DOCUMENT CHANGE REQUEST

DCR number 304	Changes required for: General	Originator: S JEFFERY
Date: 2006/11/14	Date sent: 2006/11/14	Organisation: ESA/ESTEC
Status: IMPLEMENTED

Title:	Transistors Low Power PNP, based on type 2N4033		
Number:	5202/008	Issue:	1

ESCC Detail Specification No. 5202/008

1.6.1 Metal Can Package (TO-39) - 3 lead

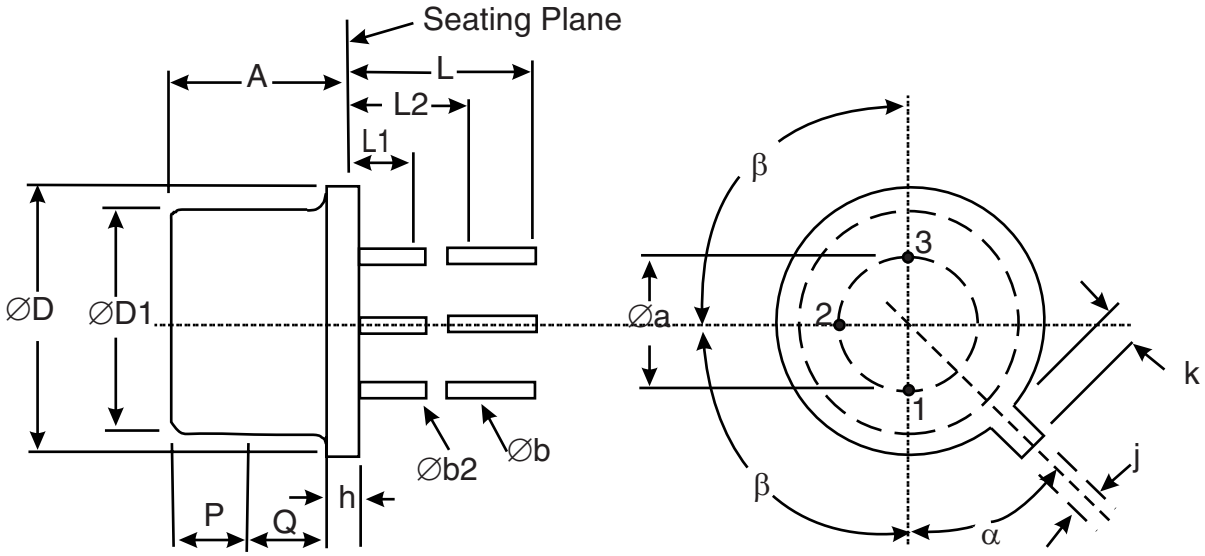
8. Figure 2 re-named "Physical Dimensions and Terminal Identification"; Figure 2(a) amended to reflect the TO-39 package currently supplied. Notes revised, including addition of a terminal identification note.

9. Para. 4.3.3 Terminal Strength: Erroneous text "Applied Force: 2.5Â±0.1 Newtons" deleted.
10. Para. 4.4.1 Case requirements for Variants 01 and 02 corrected to reflect a TO-39 metal can.

1. Terminal identification is specified by reference to the tab position where Lead 1 = emitter, Lead 2 = base and Lead 3 = collector.
2. Applies to all leads.
3. Øb2 applies between L1 and L2. Øb applies between L1 and 12.7mm from the seating plane.

1.7 FUNCTIONAL DIAGRAM

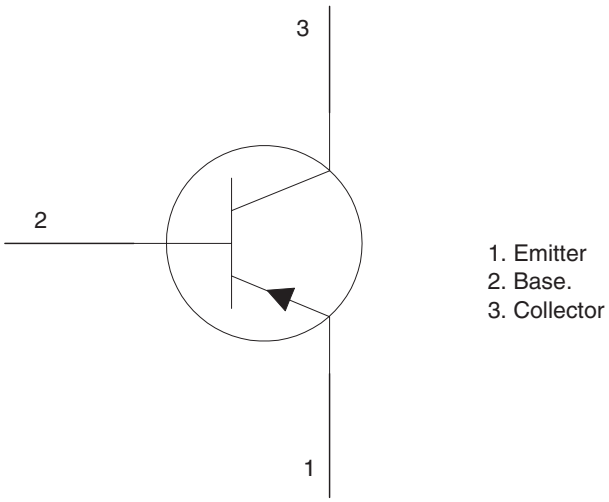
13. Figure 3 (Functional Diagram): Note added to clarify that the lids of the CCP packaged devices are not connected to any terminal.
14. Table 2, Characteristic "D.C. Forward Current Transfer Ratio" has been changed to "Forward-Current Transfer Ratio".

NOTES:
1. For TO-39, the collector is internally connected to the case.
2. For CCP the lid is not connected to any terminal

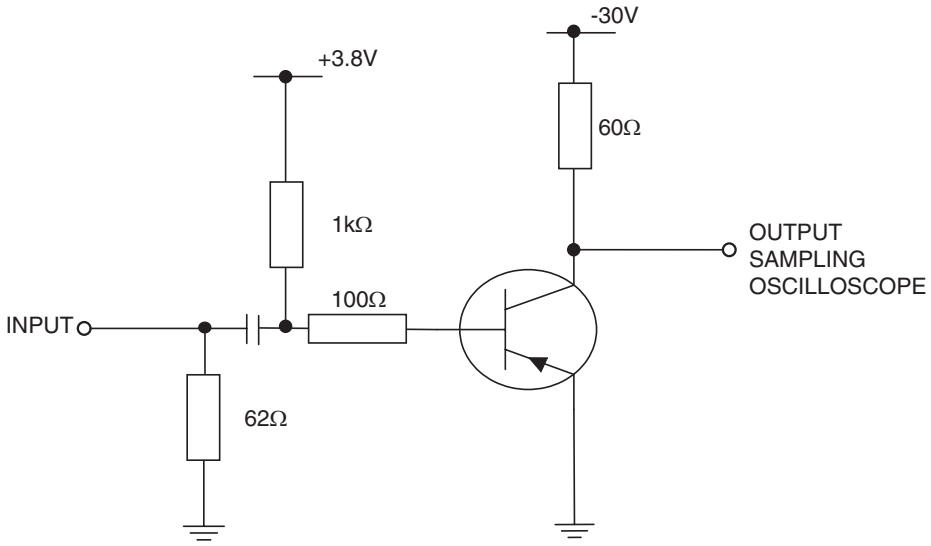
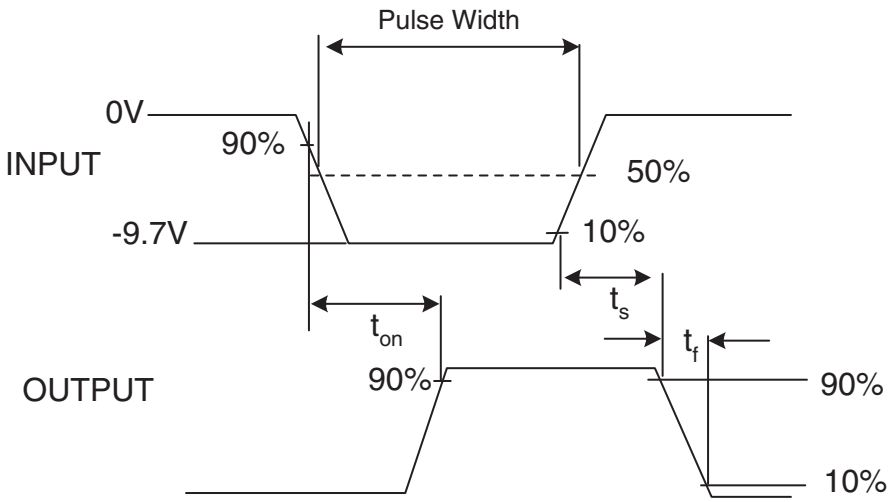
17. Table 2 and Figure 4: The Switching Times characteristics have been amended to reflect the new format.
18. Table 3 (High and Low Temperature Electrical Measurements): 100% inspection has been replaced by a sample of 5 components with 0 failures, or 100%, in line with the new Generic 5000 Issue 3.

1. Pulse measurement: Pulse Width ≤ 300µs, Duty Cycle ≤ 2%
2. For AC characteristics read and record measurements shall be performed on a sample of 32 components with 0 failures allowed. Alternatively a 100% inspection may be performed.
3. t_{on}, t_s and t_f shall be measured using the following test circuit. The input waveform shall be supplied by a pulse generator with the following characteristics: Z_{OUT} = 50Ω, t_r = t_f ≤ 20ns, Pulse Width = 10±1µs, Duty Cycle ≤ 2%. The output waveform shall be monitored on an oscilloscope with the following characteristics: Z_{IN} ≥ 100kΩ, C_{IN} ≤ 12pF, t_r ≤ 10ns.
